VILLAGE OF KIMBERLY, WI
NOTICE OF VILLAGE BOARD MEETING

**Village of Kimberly
Request for
Plan Commission Recommendation**

ITEM DESCRIPTION: Aspire Phase 2 Site & Building Plan Review

Re: Site Plan & Stormwater Management Plan Review
Aspire-Phase II (Heritage-MSP Kimberly)
McM. No. K0001-09-24-00338.04

STREET AND UTILITY CONSTRUCTION
VILLAGE OF KIMBERLY
 COBBLESTONE LANE

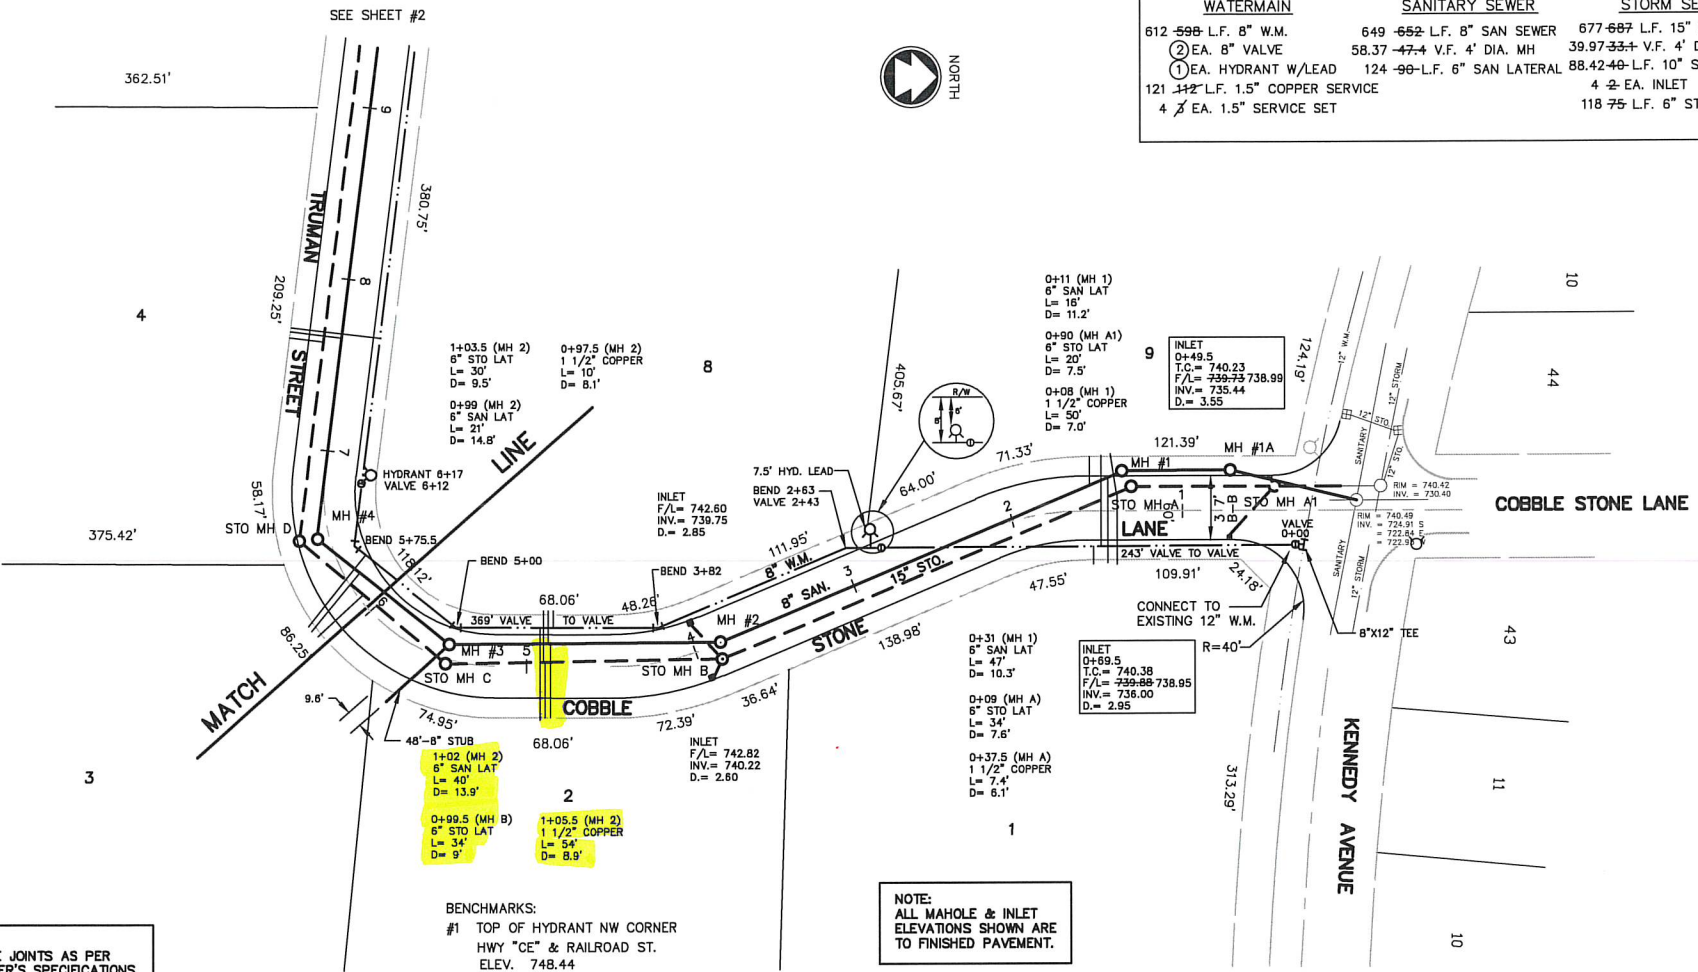
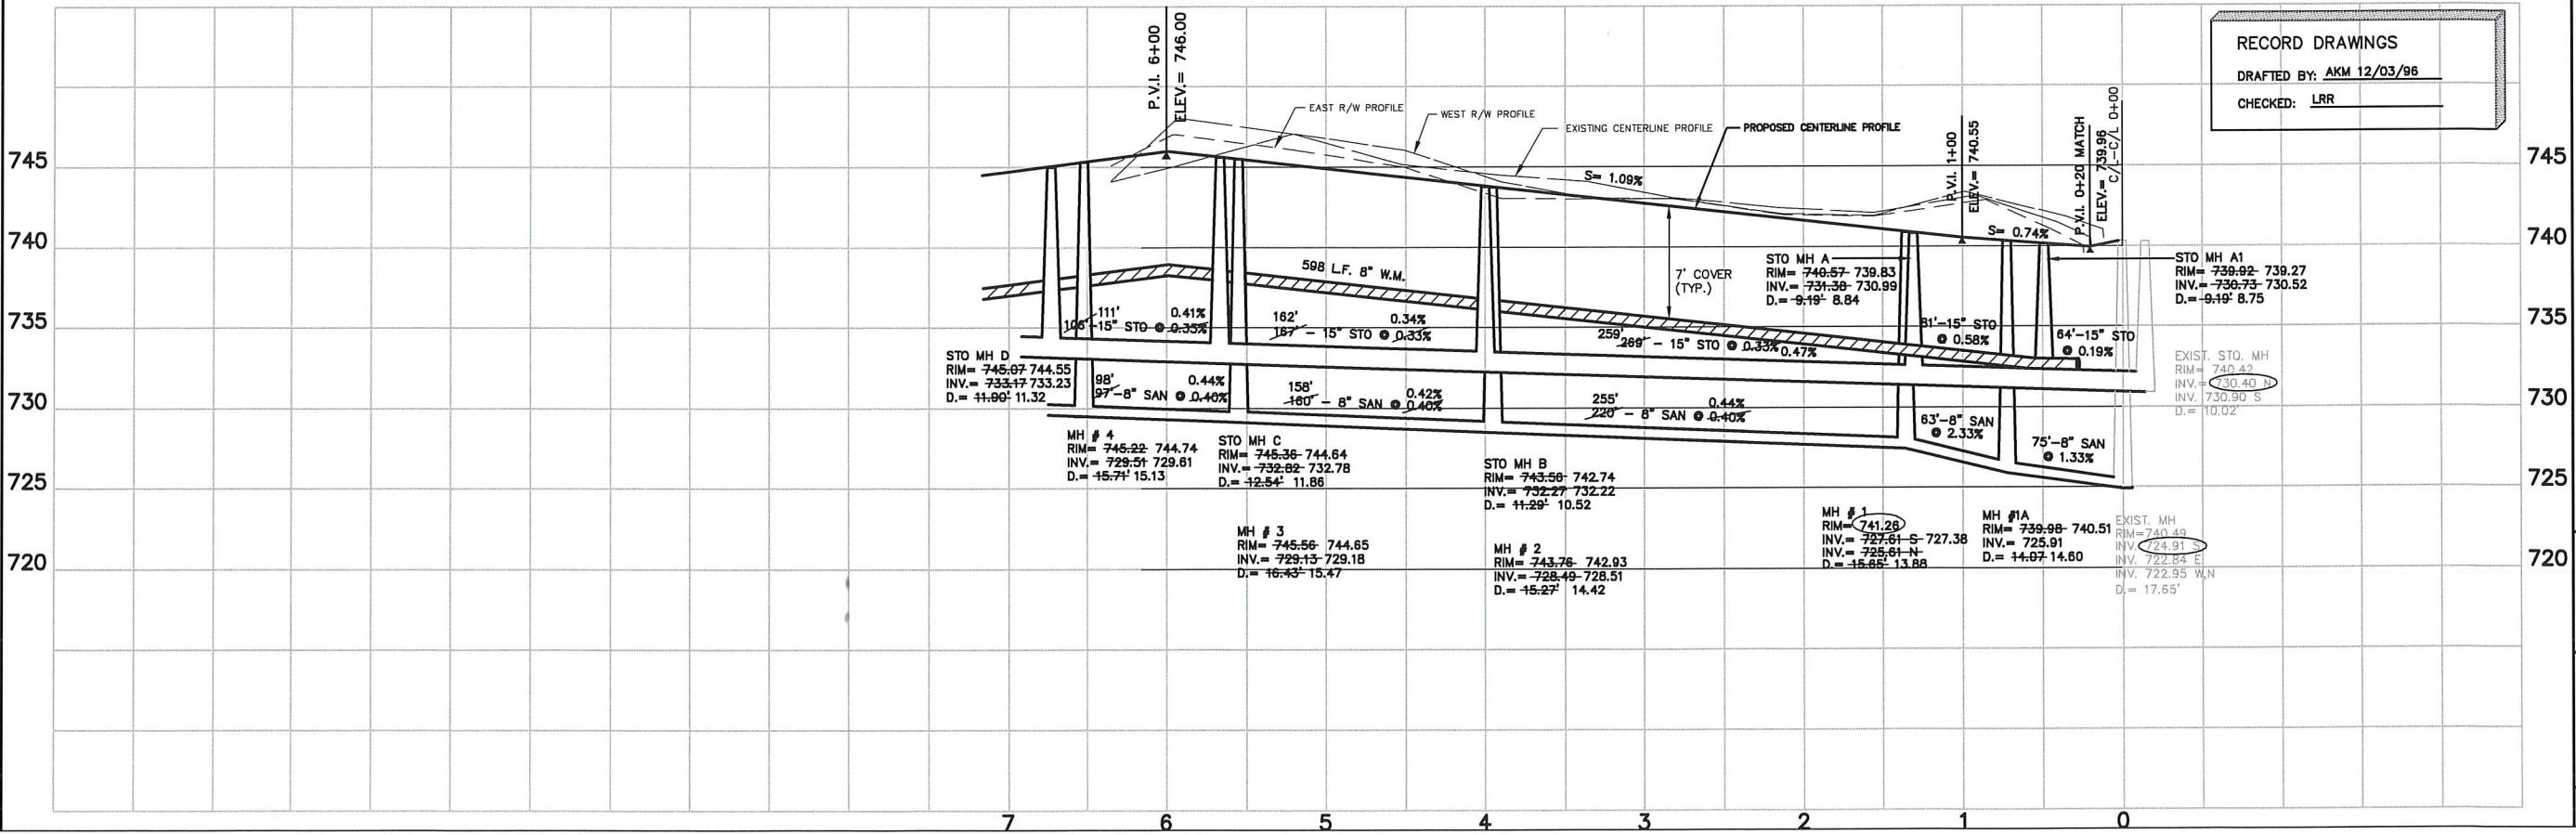
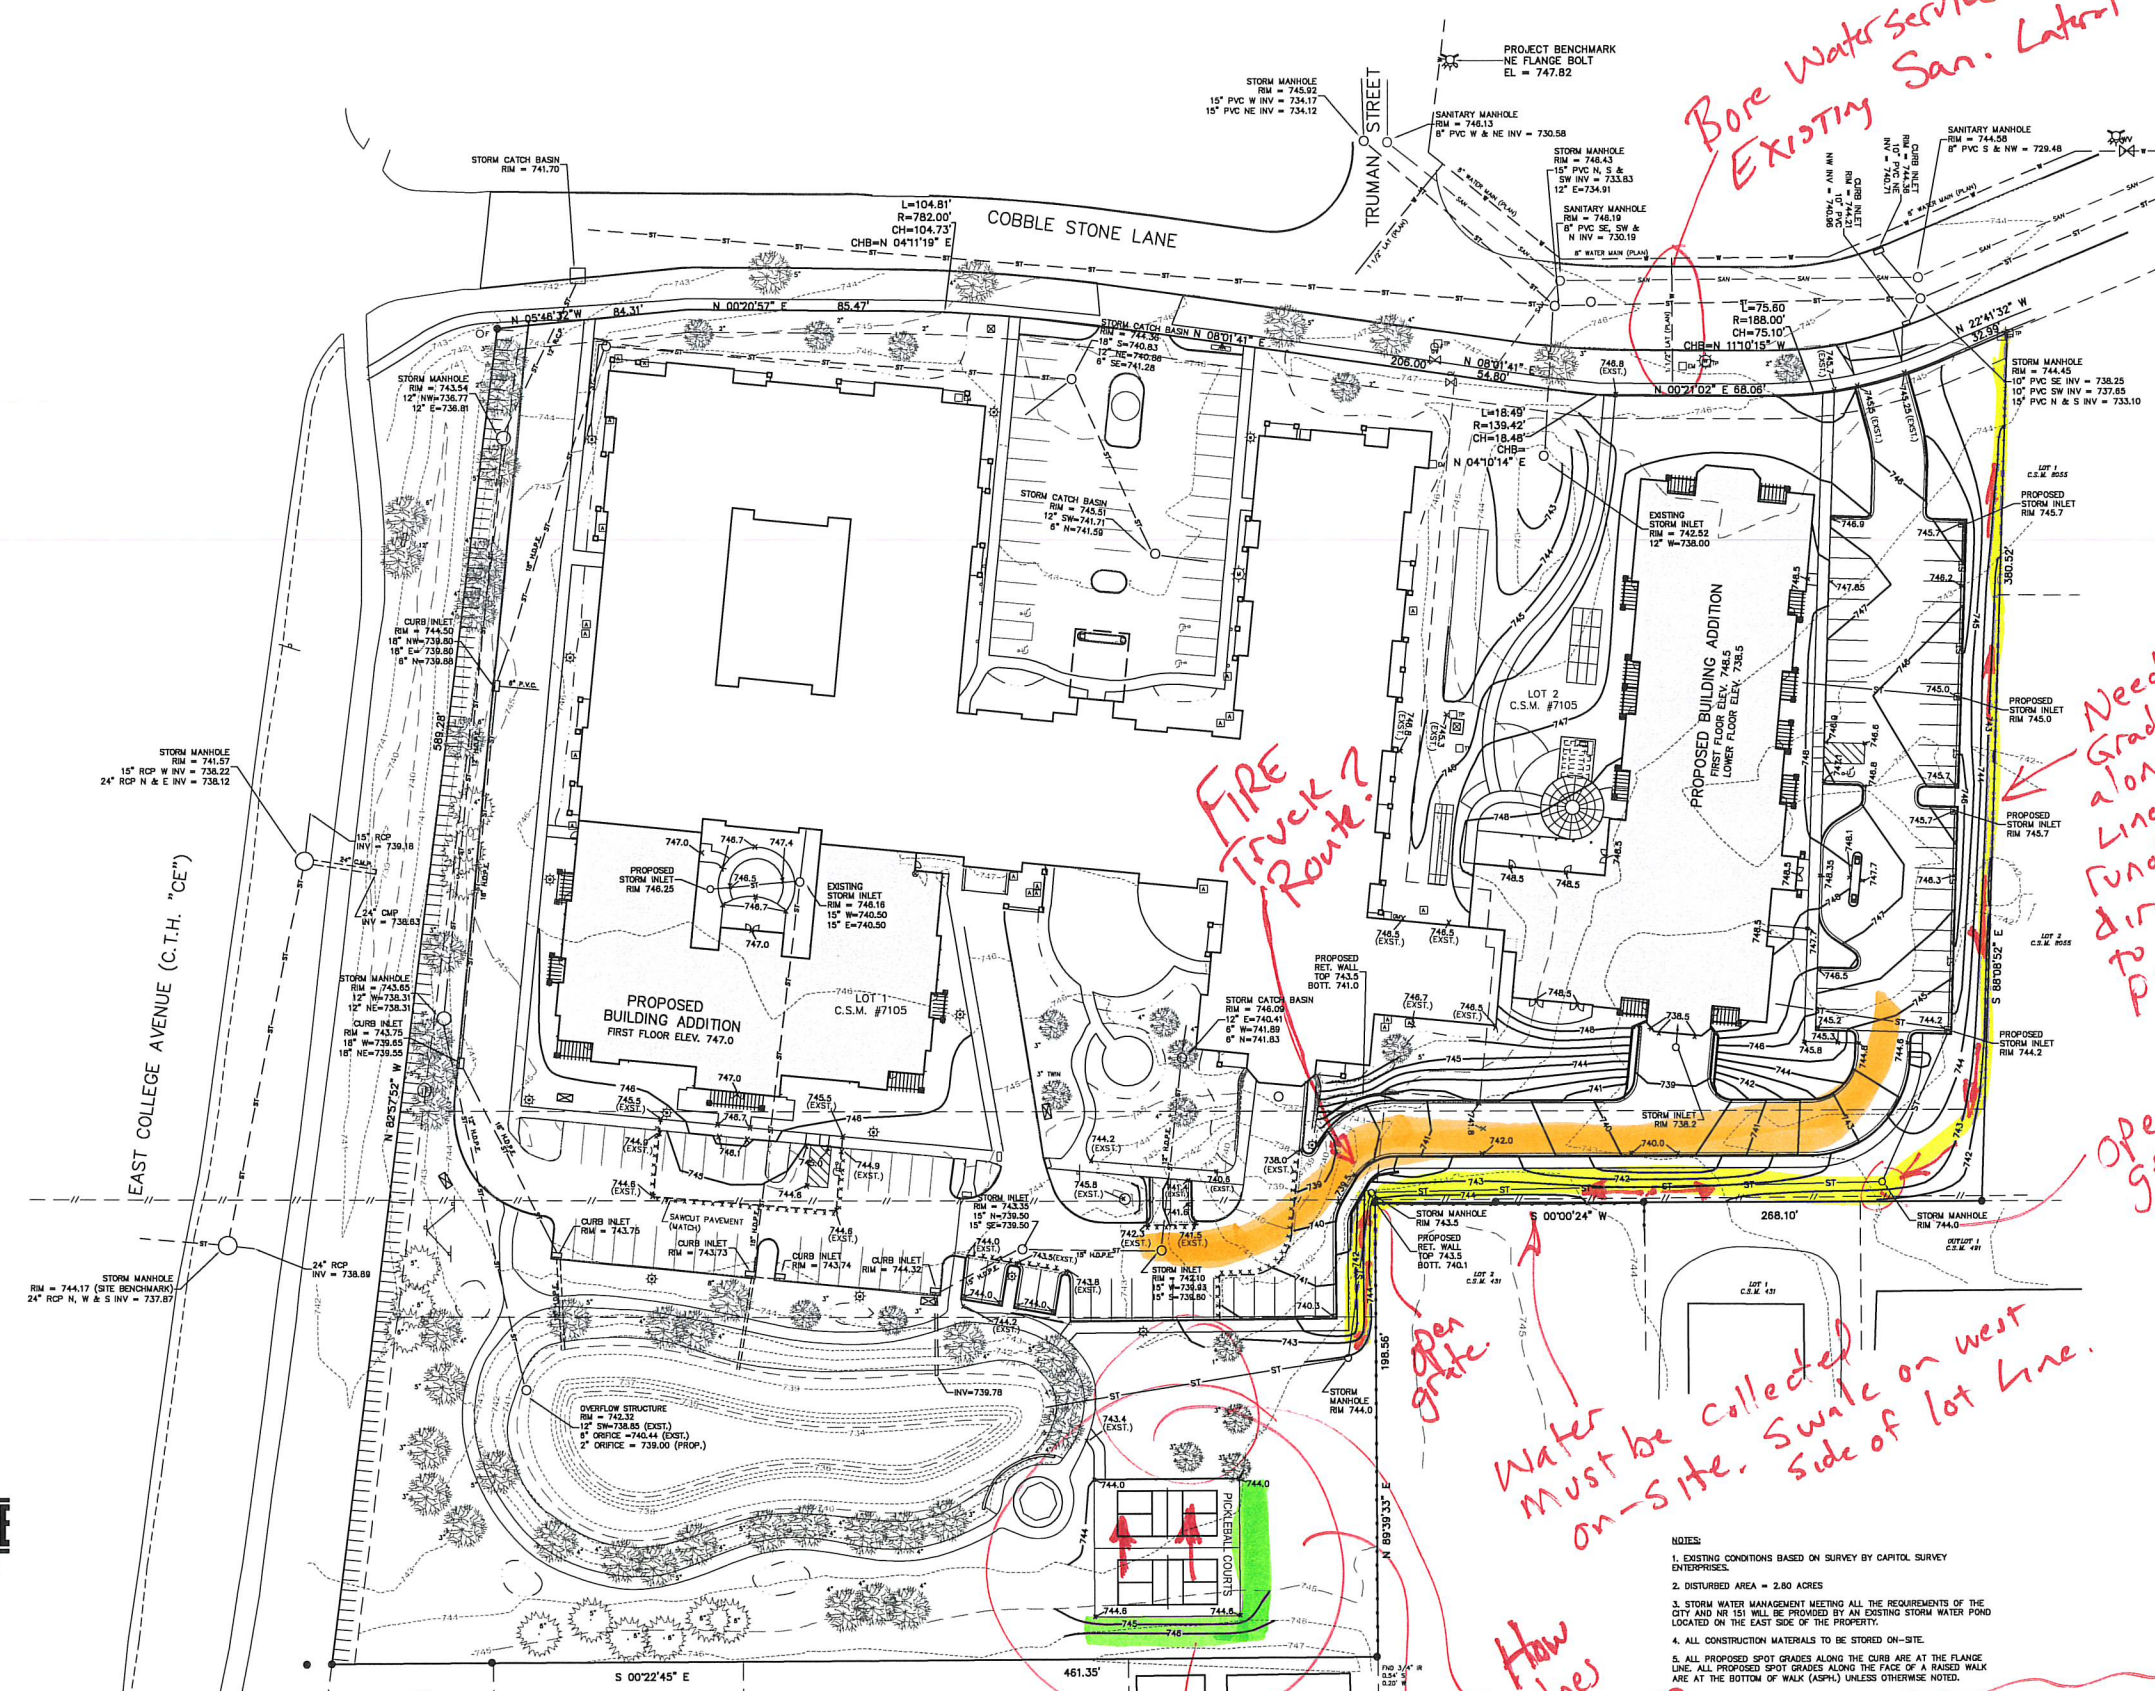
1. An existing 6-inch sanitary lateral exists for the new expansion and should be used. (See the attached record drawing for the location and approximate depth.)

4. An existing 6-inch sanitary lateral exists for the new expansion and should be used. See the attached record drawing for the location and approximate depth.

SITE GRADING PLAN C2.0

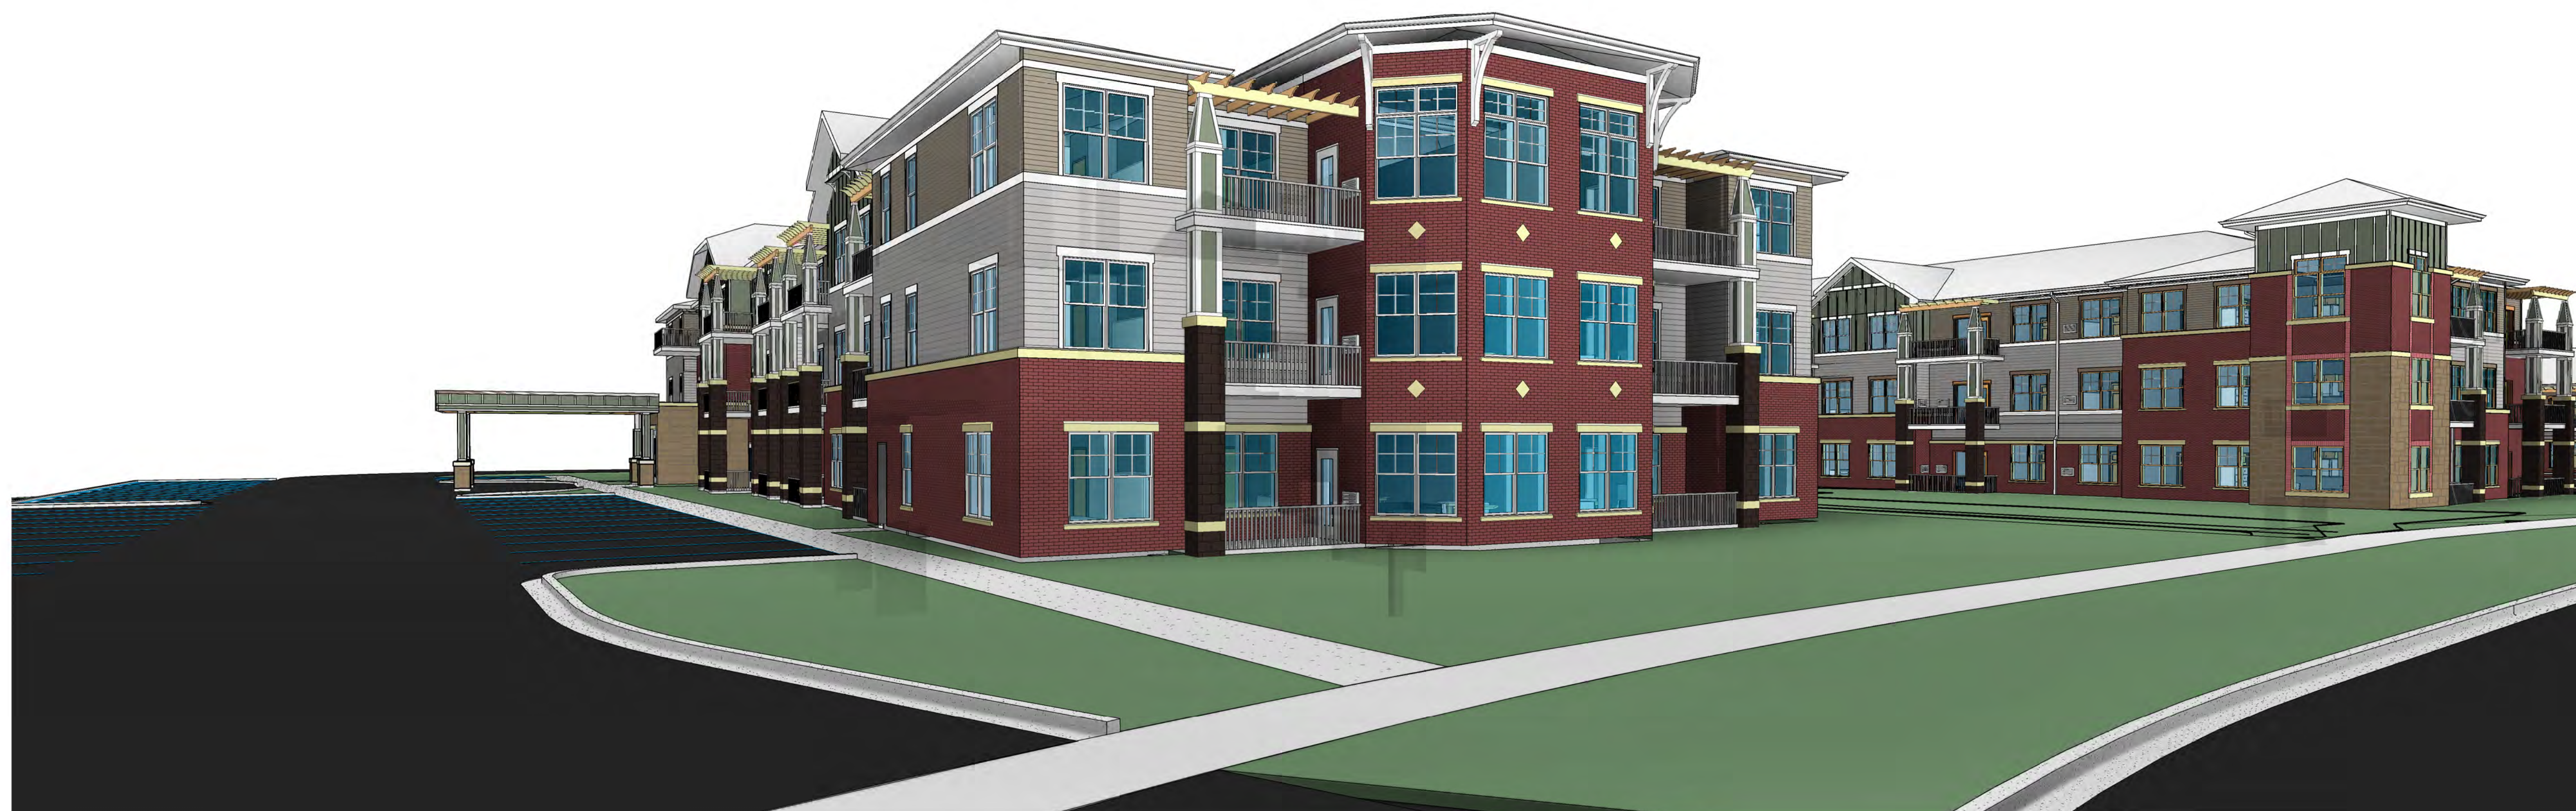
- iv. Summary of overall impervious and pervious areas is required.
2. Site/Grading Plan
 - a. North lot line spot elevation required to ensure proper drainage.

- b. Drainage of pickleball court area to be addressed.
 - c. East lot line spot elevations required to ensure proper drainage.
3. Erosion Control
 - a. An Erosion Control Plan is required.

3. Drainage along the rear yards of Railroad Street also requires collection of runoff so it does not impact those properties. (see attached markup)
4. More detail is needed as to how drainage around the pickleball courts will be handled. Currently it appears as though the water from the court has no discharge point. How does this surface water drain to the pond?
